ADDRESS : 109 GRAHAMRIDGE LN
 CONTRACTOR : SHRIEVES MICHAEL
 OWNER : ANDREWS DONALD R & MARGIE N #3
 PARCEL : 04-0664- - -0038- -34-
 APPL NUMBER: 07-50017464 CP NEW RESIDENTIAL (SFD)
 DIRECTIONS : WYNDHAM PLACE #3 PHII - 401N TO
 LAFAYETTE RD RT GO CHALYBEATE SRINGS RD
 RT TO WELLS RD LEFT T RAWLS CH RD RT
 APPROX .5MILES S/D ON RT TAKE 1ST PAVED
 RT ON LEFT LOT ON LEFT OF CULDESAC. JD

RE: **Structural Analysis, Revised**
Triangle Residential Designs, TRD Stock Plan TRD-2-2249
John Wilson, 3008 Rawls Church Road, Fuquay-Varina, NC, 27526
Residence Plan

Lot #3, Wyndham Place Sub'd.
Hamett County, North Carolina
Hamett County Permit No. _____

[Signature]
07-24-2007
96-00450-A

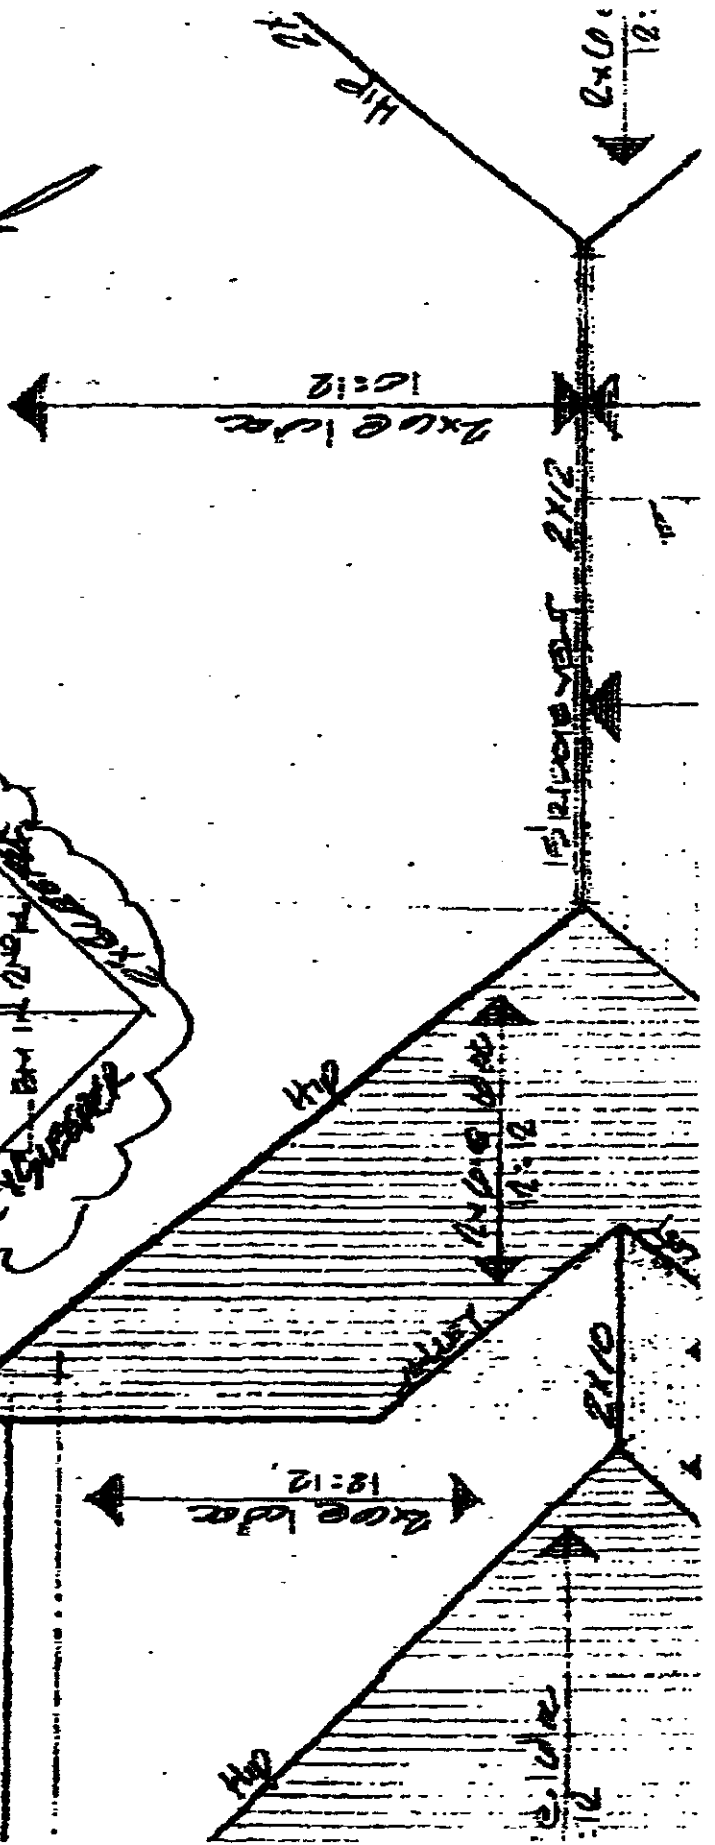
At your request, I have reviewed the structural requirements for placing a floor over the family room. The developable areas of this floor area will be a game room and has been designed for a 40 psf live load. In addition the roof will be modified to include an eight foot wide gable roofed dormer.

The attached partial plans provide the details for this structural modification. The following modifications are required:

- 1) The game room dormer sidewall carrier rafters are acceptable as 2-2"x8", #2SPF, minimum rafters.
- 2) The side-to-side second floor ceiling/roof carrier beam remains appropriate as 2-1 3/4"x14" Laminated Veneer Lumber, LVLs. (minimum design strength is E = 1.9x10⁶ psi; F_b = 2600 psi and; F_v = 285 psi. However, the 2-2"x12", #2SPF or #2SYP, with a 1/2"x11" steel fitch plate option will require 3-2"x12"s with the revised roof loading.
- 3) The side-to-side game room dormer ceiling joists shall be 2"x4", #2SPF, minimum placed at sixteen inch centers.
- 4) The side-to-side game room rafters are appropriate as 2"x6", #2SPF, minimum placed at sixteen inch centers. The dormer ridge shall be a 2"x8", #2SPF, minimum. The game room dormer roof valley may be constructed by over-

framing on the main roof rafters, supporting the dormer rafters on a 2"X sleeper placed on the main roof.

- 5) The side-to-side game room floor joists are acceptable as 2"X10", #2SPF, placed at sixteen inch centers.
- 6) Place a 2-1 3/4"X9 1/4" LVL with 1-2"X10" beam at the family room/nook common wall extending from the dining room stair/common wall to the rear nook wall. Provide three stud bearing support at the dining room/stair common wall, the rear side of the opening between the family room and nook (which bears over an underlying girder and pier) and the rear nook wall.
- 7) The side-to-side rear dining room/stair common wall girder span adjacent to the garage shall be installed as a 5-2"X10" member to support the point load from the front end of the beam described in item six, above.
- 8) Since a second floor-floor will be placed over the family room, the rear side and exterior walls of the family room do not need to be balloon framed as indicated on the plans.
